**Mandatory Service Bulletin for
Cessna 208 / 208B Modified with the Installation of
Survey Tail Boom Assembly and Tail Video Camera (Access Panels).
CESSNA 208 AND 208B RUDDER BELL CRANK FOULING CONDITION**

MANDATORY SERVICE BULLETIN

CESSNA 208 AND 208B RUDDER BELL CRANK FOULING CONDITION

MSB-LCAS-001 R-0

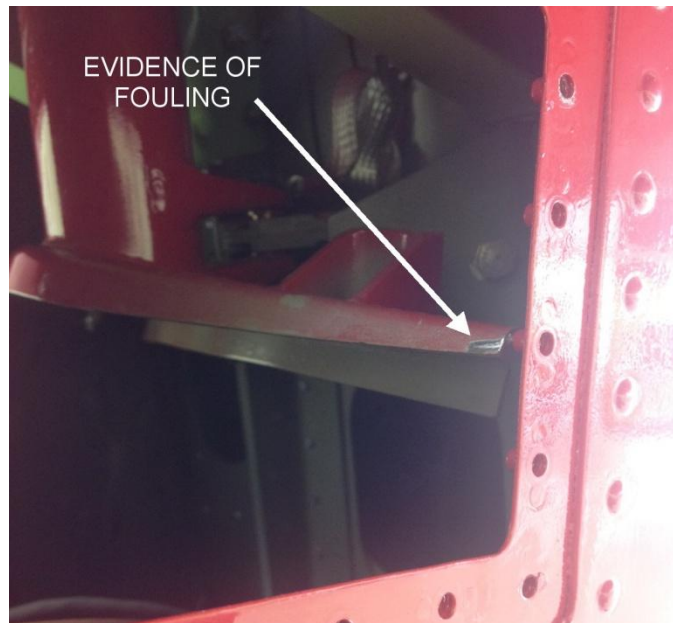
It has been determined that the rudder bell crank on some modified airplanes may foul against the mounting hardware (screws and / or anchor nuts) which secure the left hand and / or the right hand video camera access panels.

The left and right hand side video camera access panels shall be removed and the interior of the tail boom transition cone shall be inspected for fouling conditions resulting from contact between the rudder bell crank and the video camera access panel mounting hardware. Non-compliance with this mandatory Service Bulletin could result in the premature wear and / or failure of the previously mentioned components. See picture below for evidence of the potential condition.

1. Remove video camera access panels (PN LCA00306-004).
2. Inspect the AN526C-832R8 screws for evidence of wear as a result of slight contact or an existing fouling condition. If evidence of contact is found; replace all of the AN526C-832R8 screws with AN526C-832R6 screws.
3. If the rudder bell crank is capable of contacting any of the MS21070-08 anchor nuts (after installation of the shorter AN526C-832R6 screws), or is closer than 1/8 inch; remove the offending anchor nut and remanufacture the video camera access panel from .063" 2024 T3 aluminum, being certain to eliminate the screw hole that corresponds to the removed anchor nut.

1. If contact was found and remedied by switching to the shorter AN526C-832R6 screws, fix a placard to the access panels that states "SECURE ACCESS PANEL WITH AN526C-832R6 SCREWS".
2. If contact was found and remedied by removal of an existing MS21070-08 anchor nut and remanufacturing the access panel from .063" 2024 T3 aluminum; placard the access panel(s) with appropriate alignment marks to ensure correct placement when secured to the aircraft.
